RE: SES Solar One Project
Applicant's Responses to CEC and BLM Data Requests Set 1, Part 1 and Set 2, Part 1
Data Requests 71-73, 76-79, 85, and 128-141

SES SOLAR ONE

In Response to CEC & BLM Data Requests
Data Requests 71-73, 76-79, 85, and 128-141

Application for Certification (08-AFC-13)

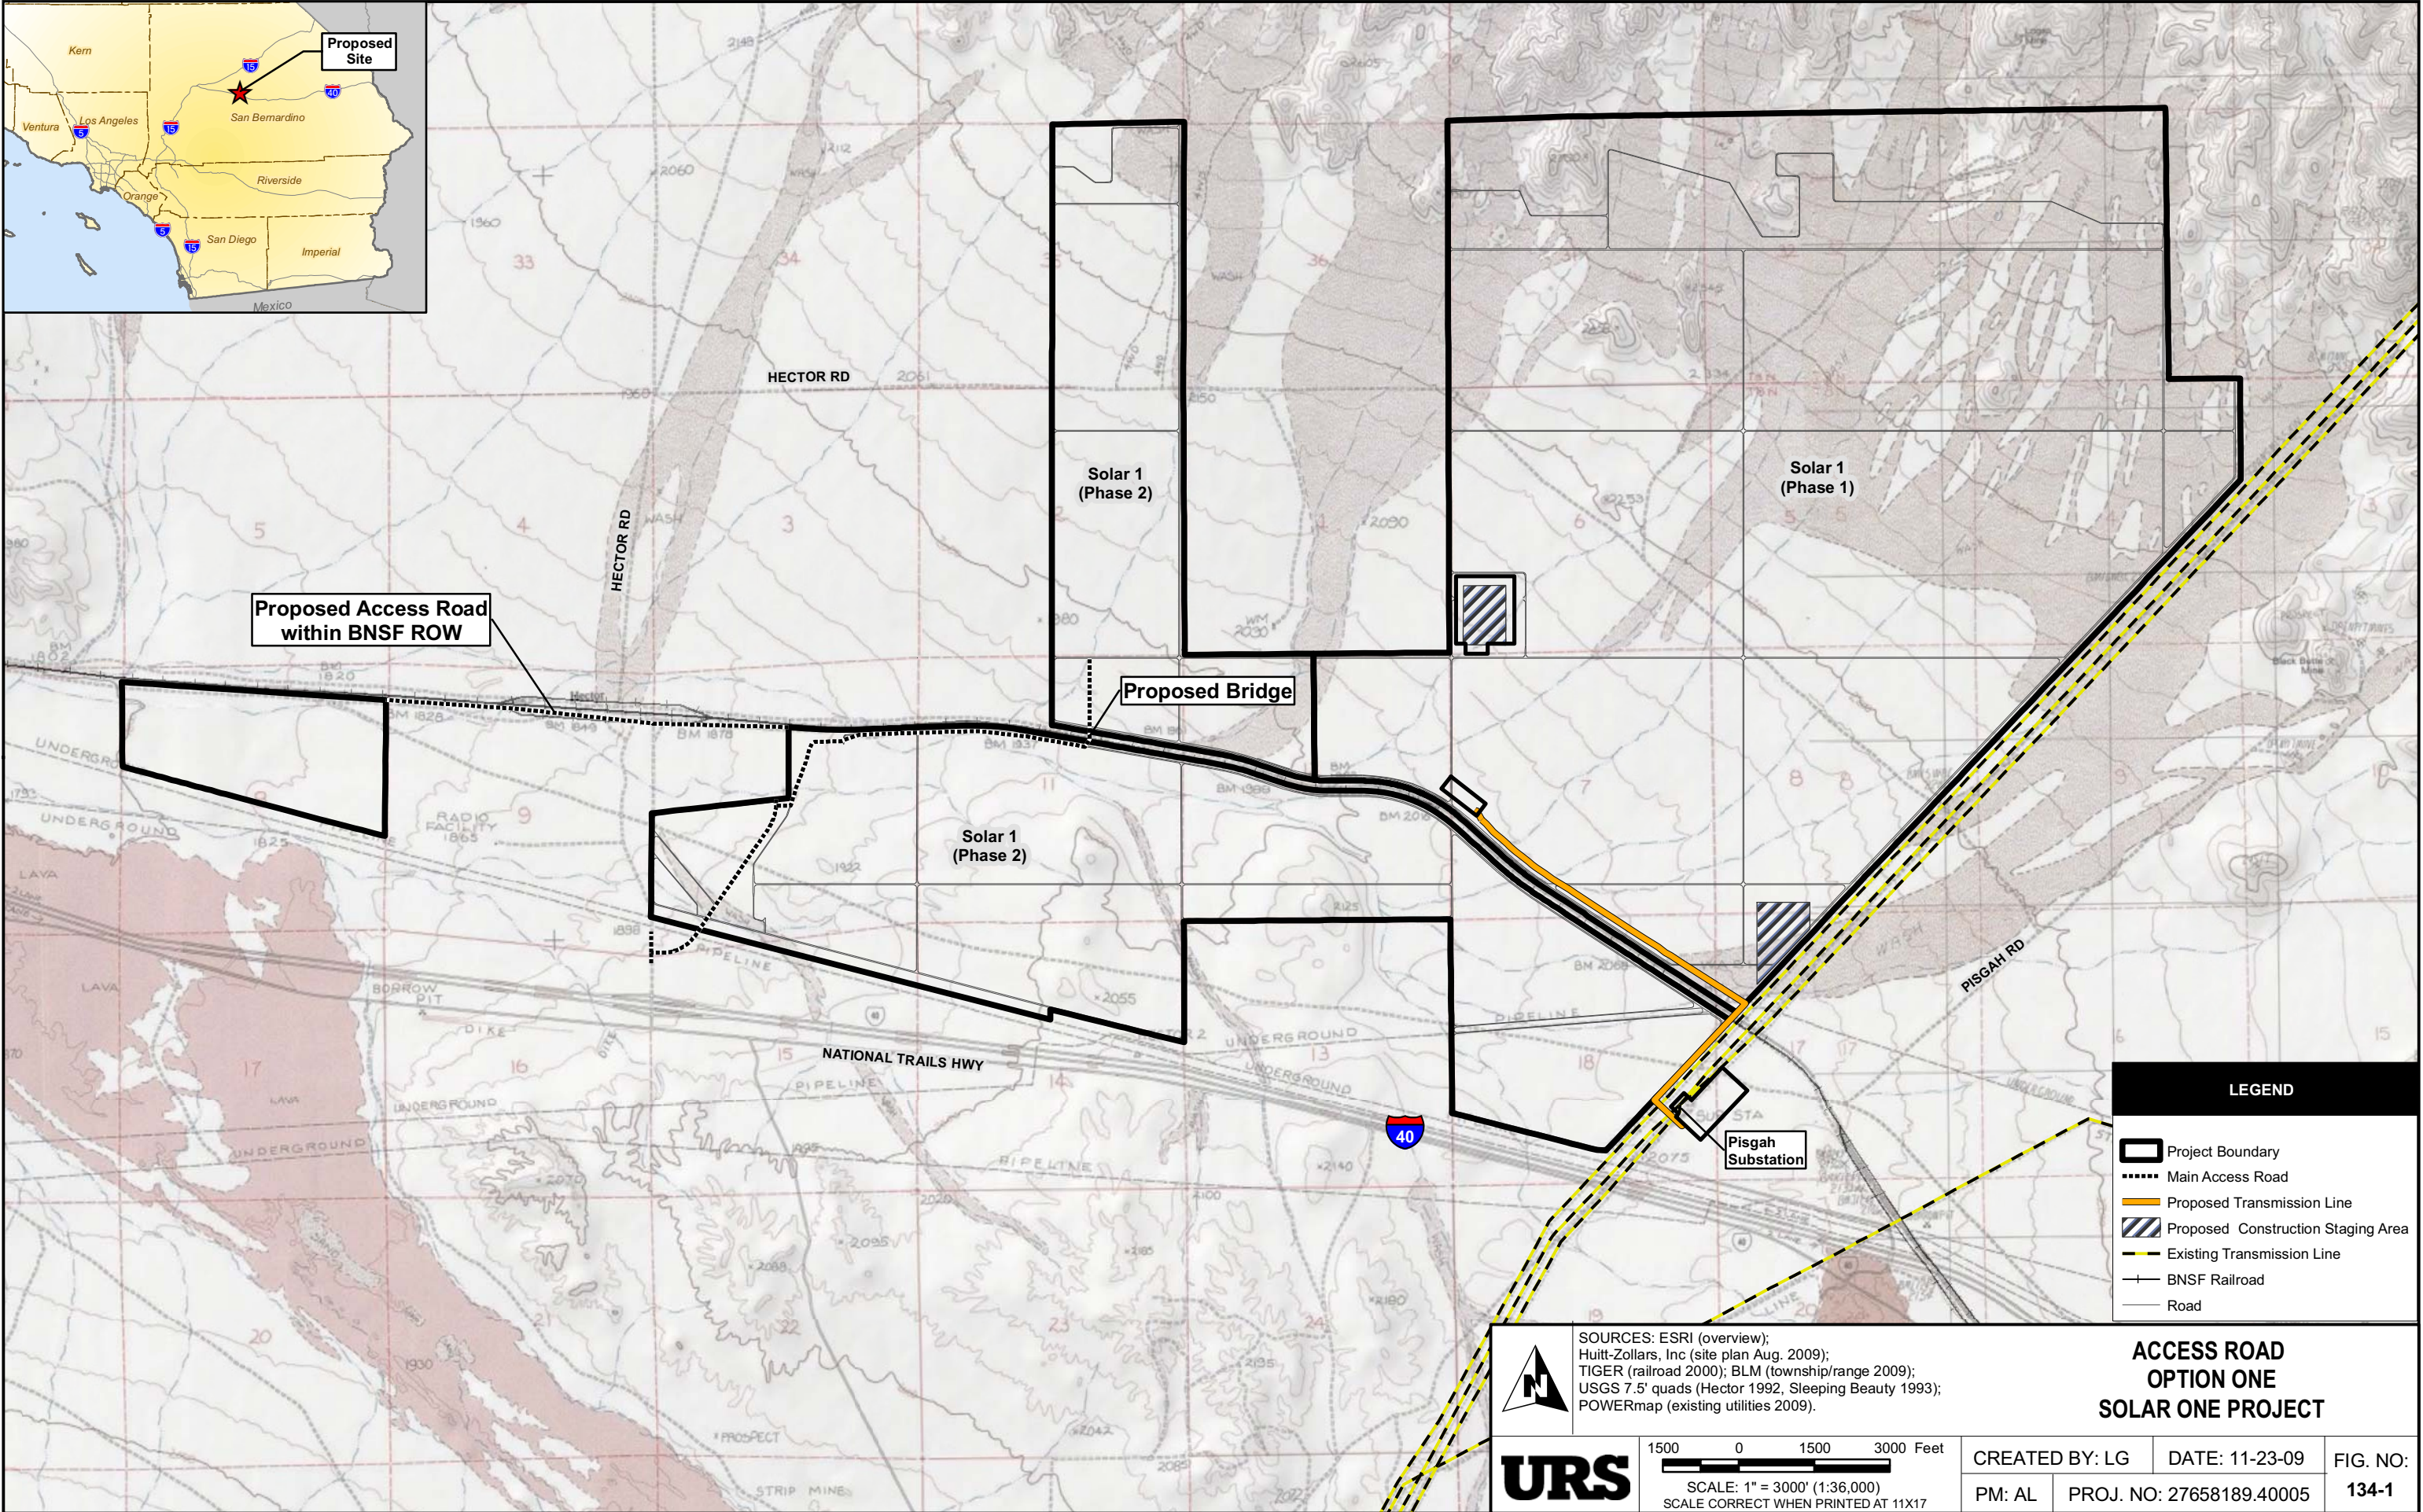
Please provide a map at a scale of 1:36,000 depicting all four of the alternative road access options.

As the Project has moved through design phases and in an effort to reduce environmental impacts, the Applicant is no longer evaluating many of the alternative road access options. Options 2 through 4, as discussed in the AFC are no longer considered to be alternative road access options. A map showing this access option at the requested scale is provided behind this response as attachment ALT-2.

DISTRIBUTION OF
SENSITIVE BIOLOGICAL RESOURCES
SOLAR ONE PHASE 1

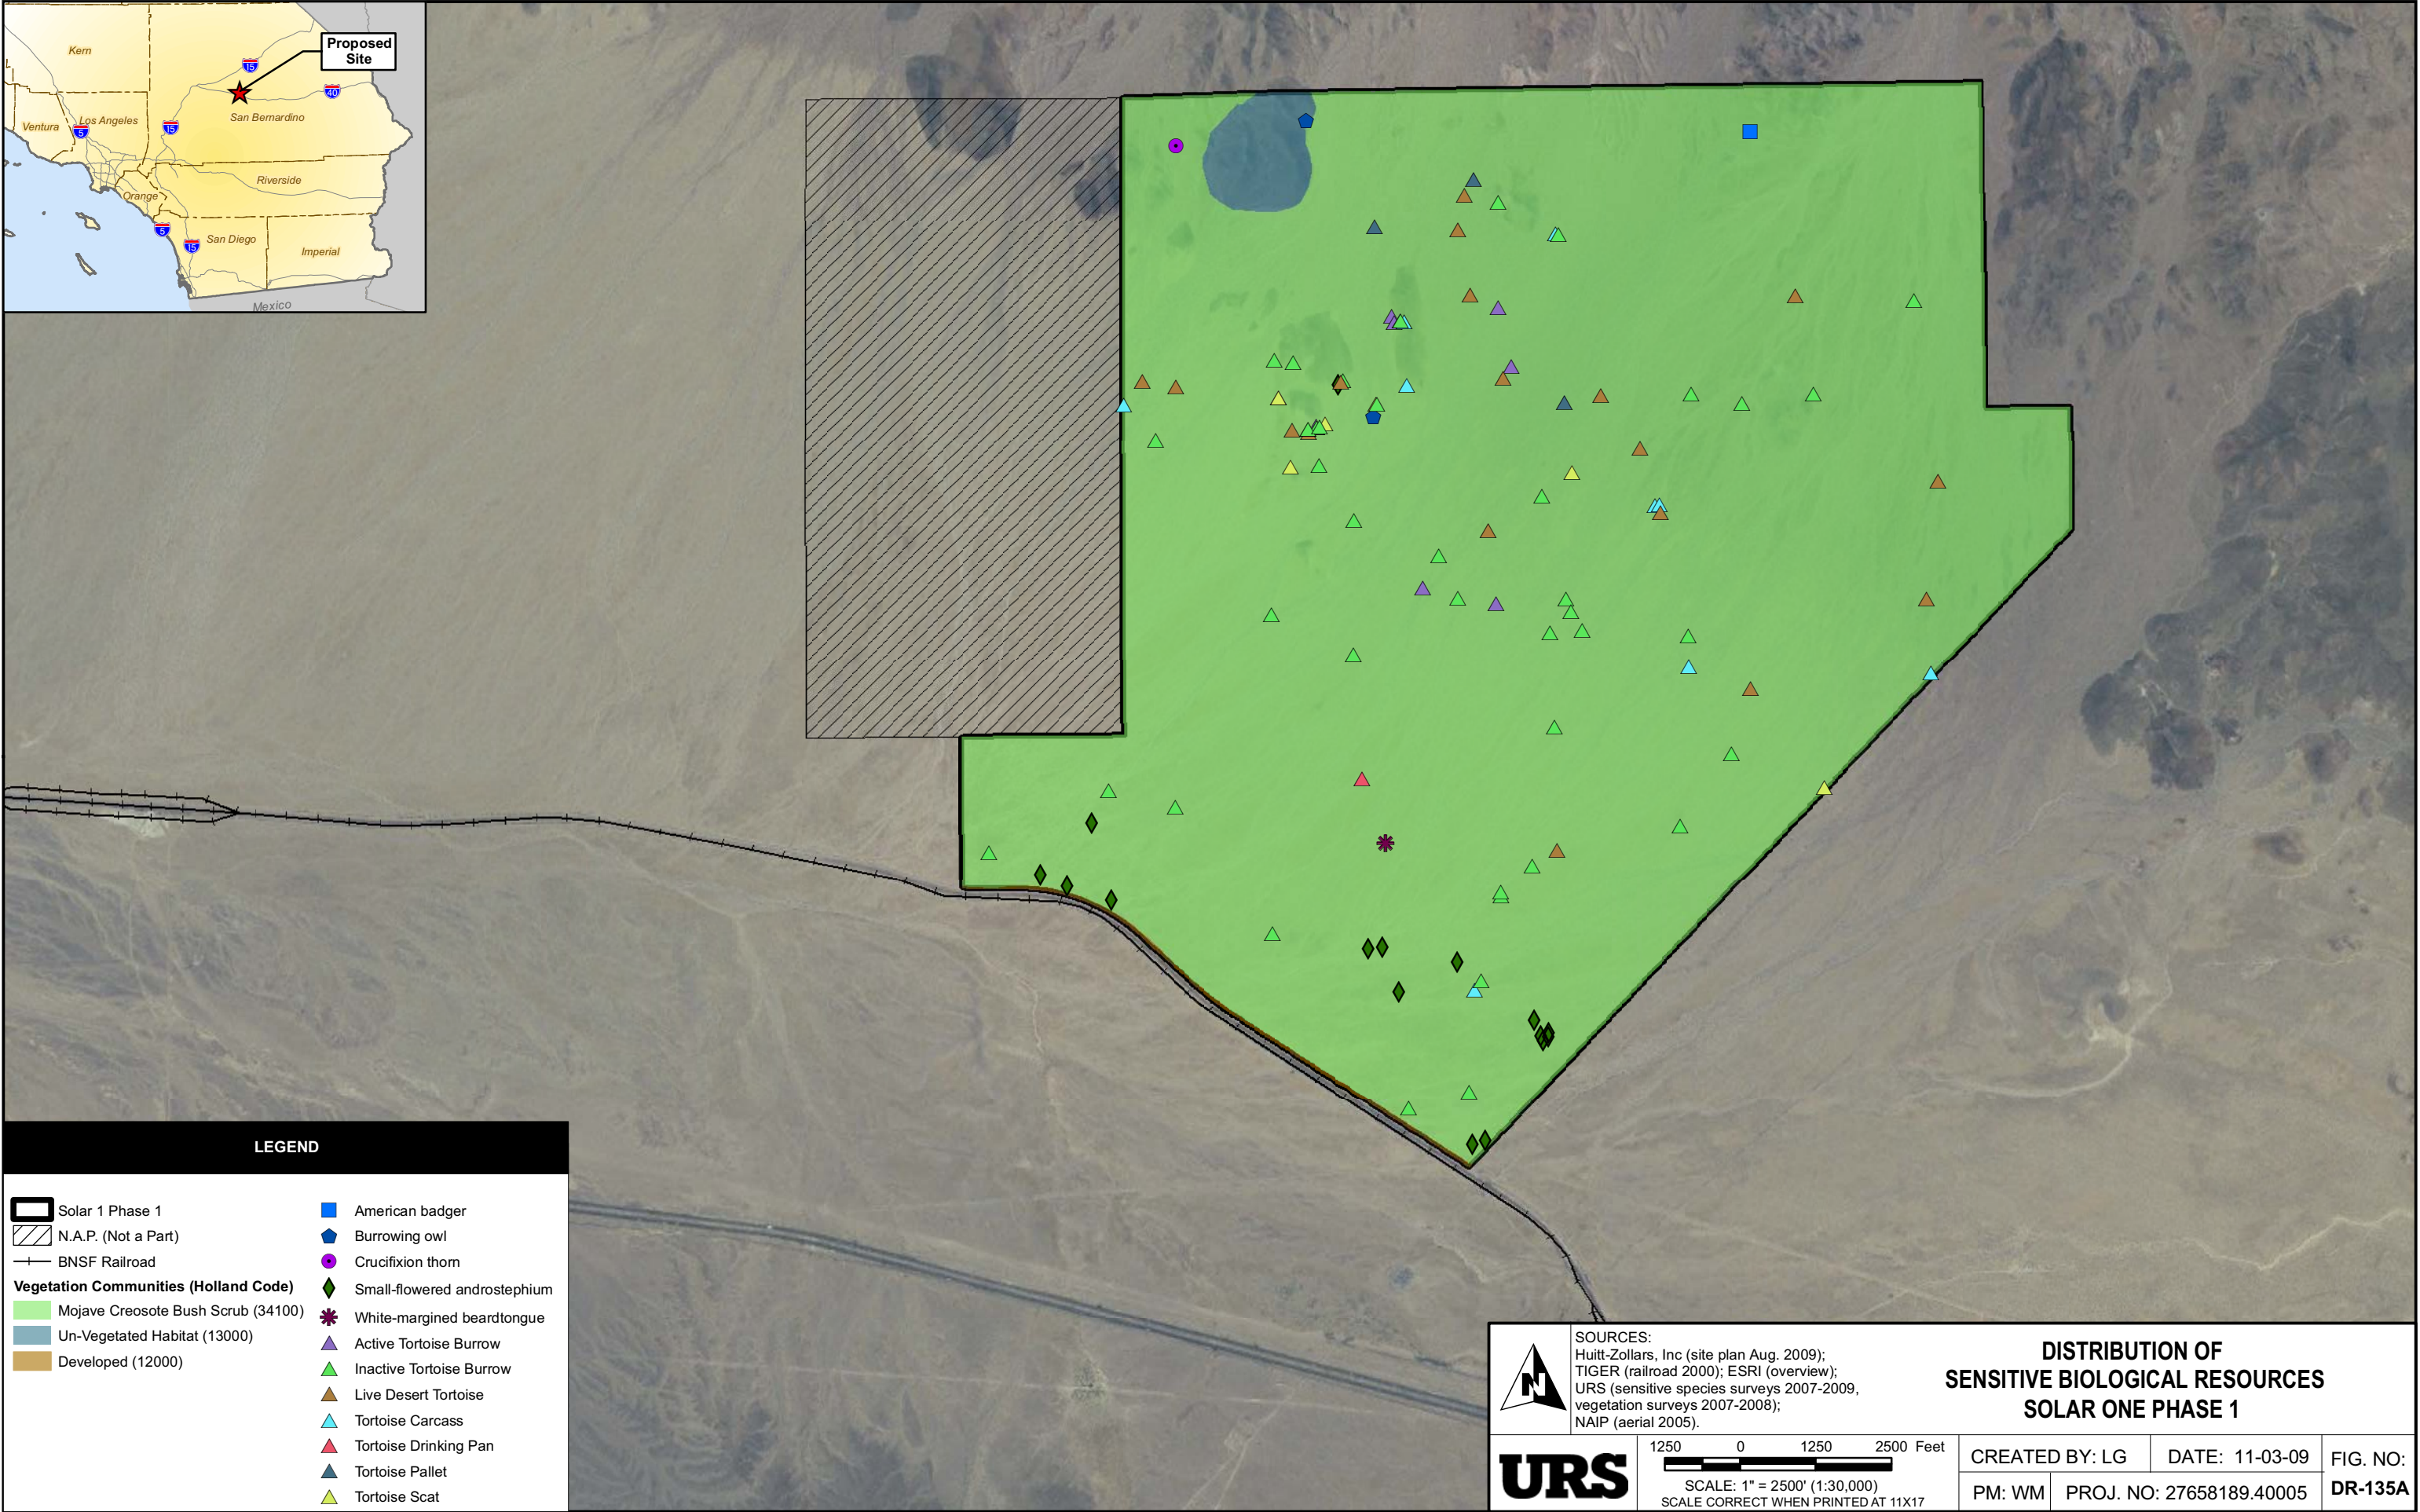
Please provide an analysis of cultural and biological impacts for Phase 1 only and for Phase 2 only. Provide this by giving us both a map illustrating distribution of resources on each phase and also a tabular list of resources on each phase.

Biological Resources: Tables showing the resources in each phase of the Project are listed below. Figures are provided behind this response as attachment ALT-3.

SHEET	1	OF	1	REVISION	
TITLE	SOLAR ONE EXHIBIT TWO				
CLIENT	Tessera Solar				
APPROVED BY:	DATE	EXP.	DATE	EXP.	
BY	DATE	APP.	DATE	APP.	
REVISIONS

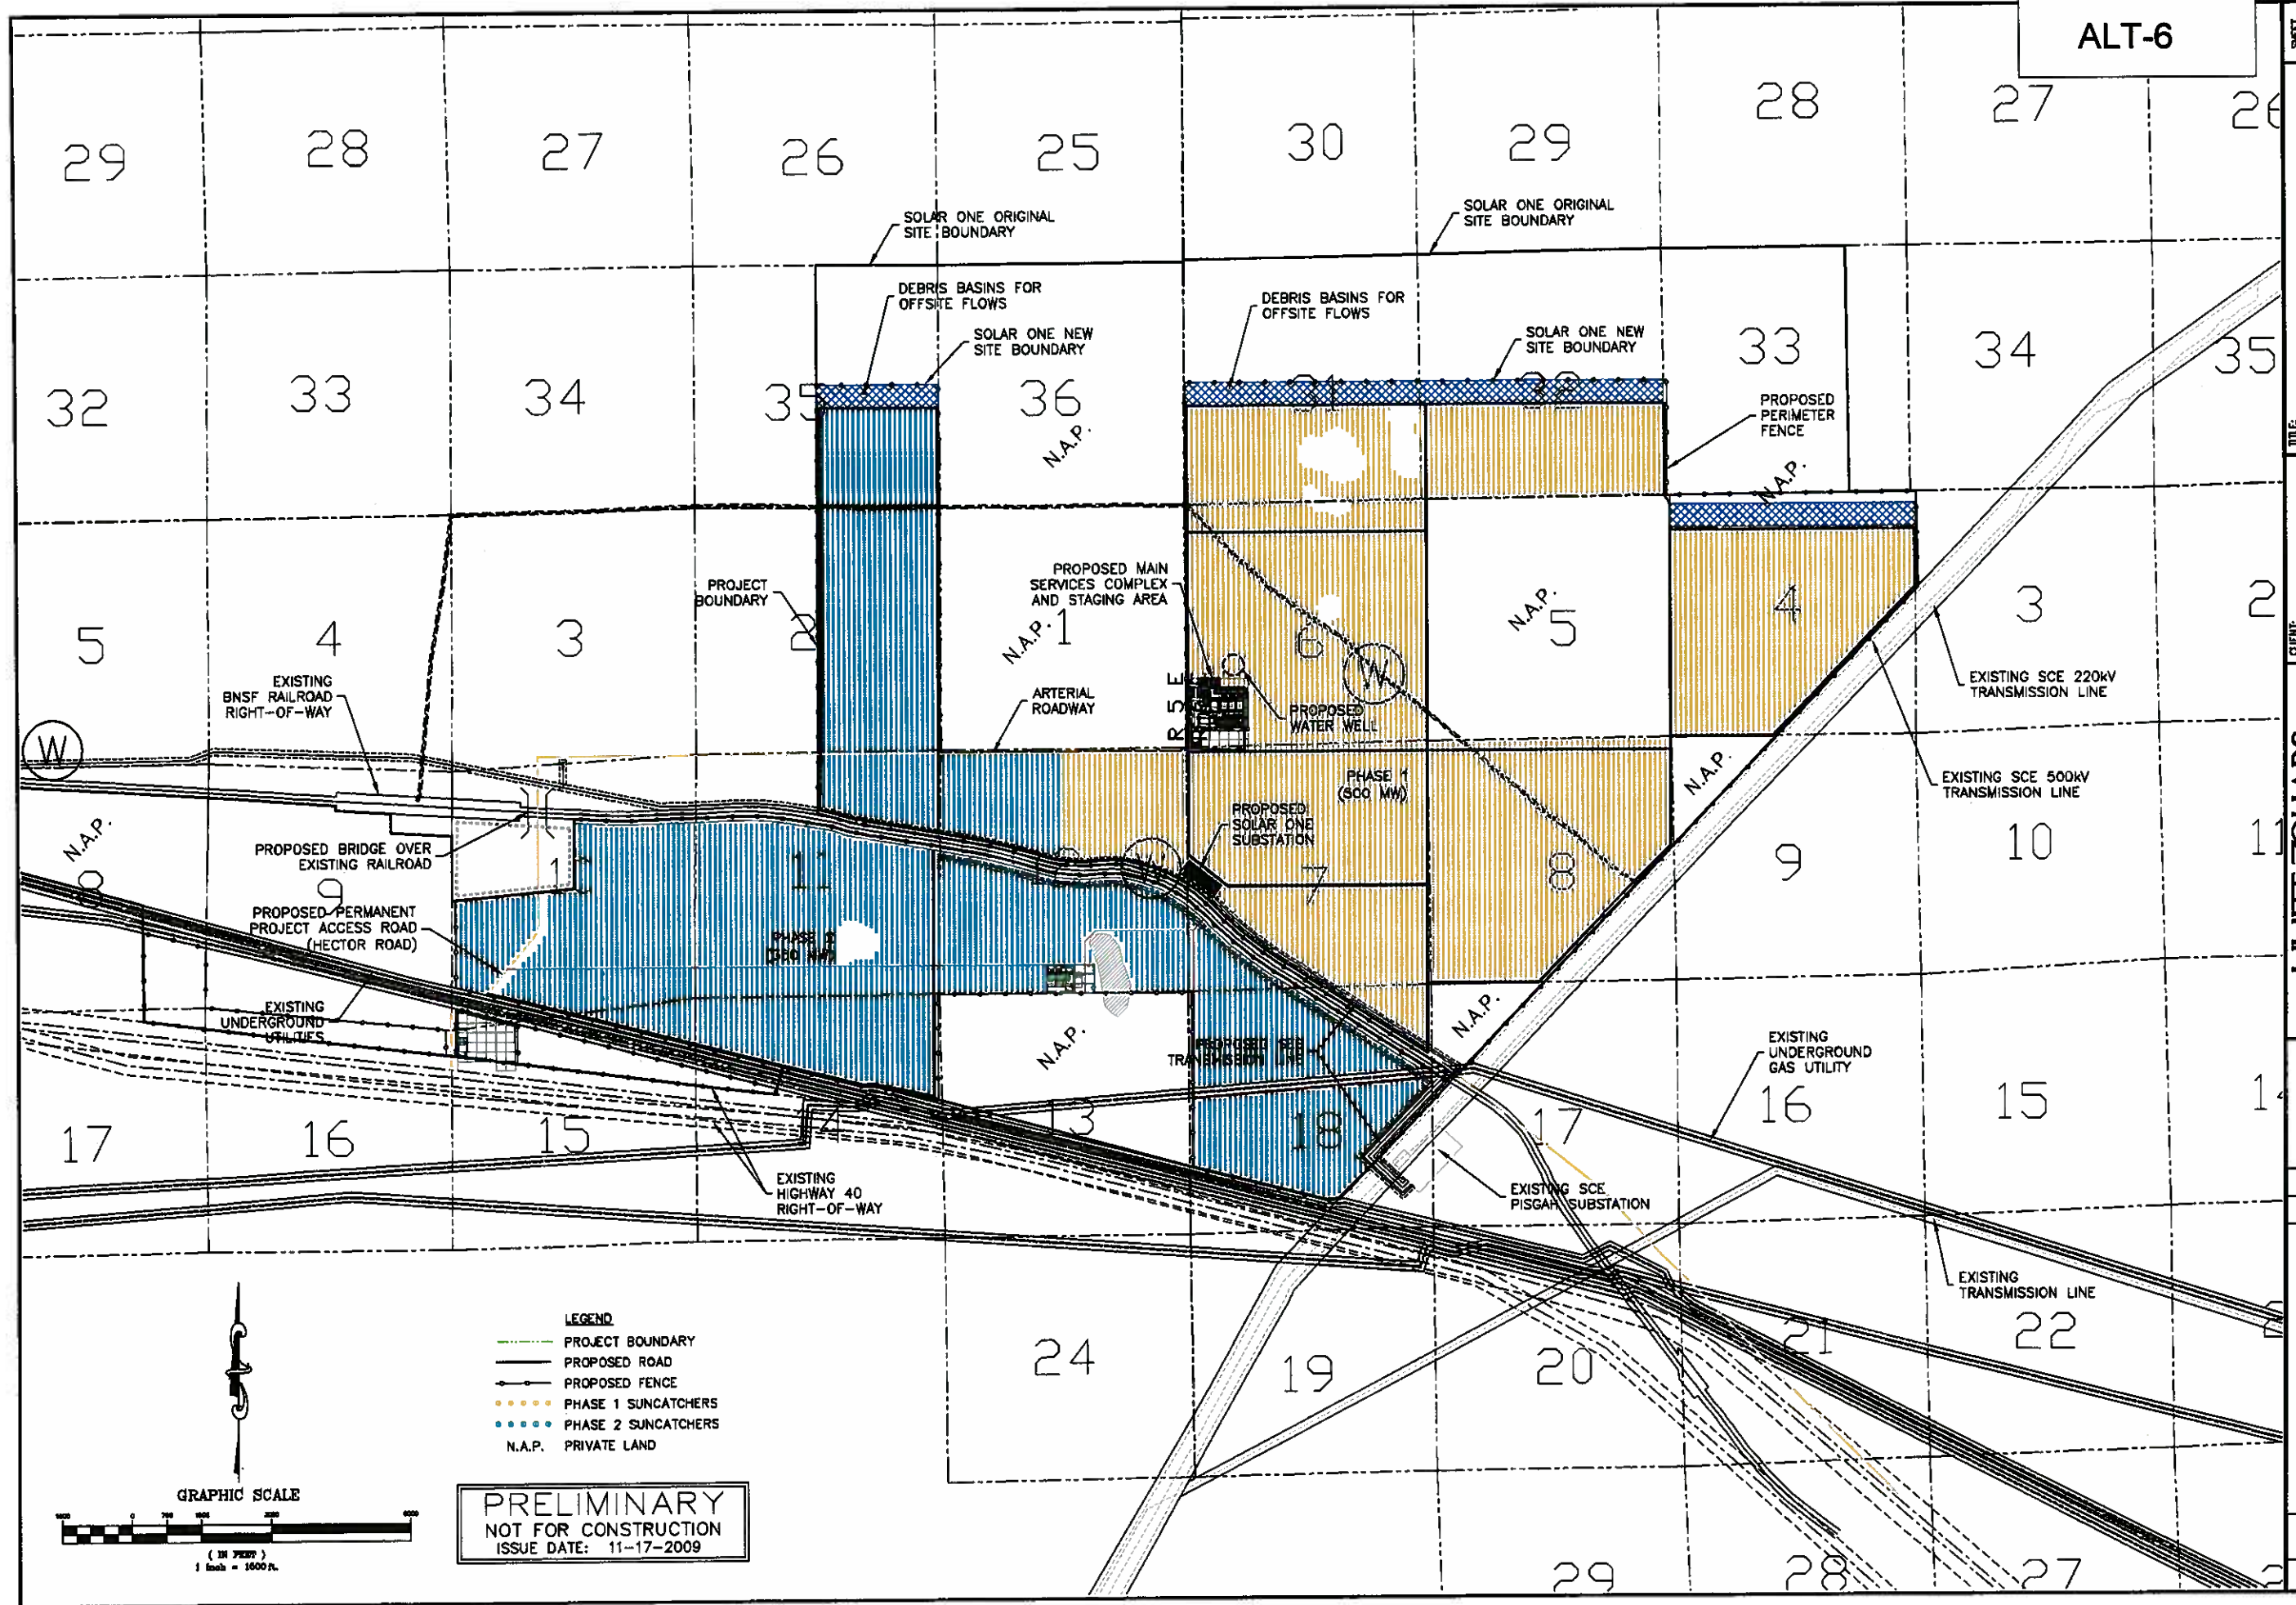
Please provide an alternative configuration for Phase 1 of the proposed project that takes these concerns (donated land and Big Horn Sheep habitat) into account.

Please refer to attachment ALT-6, located behind this response.
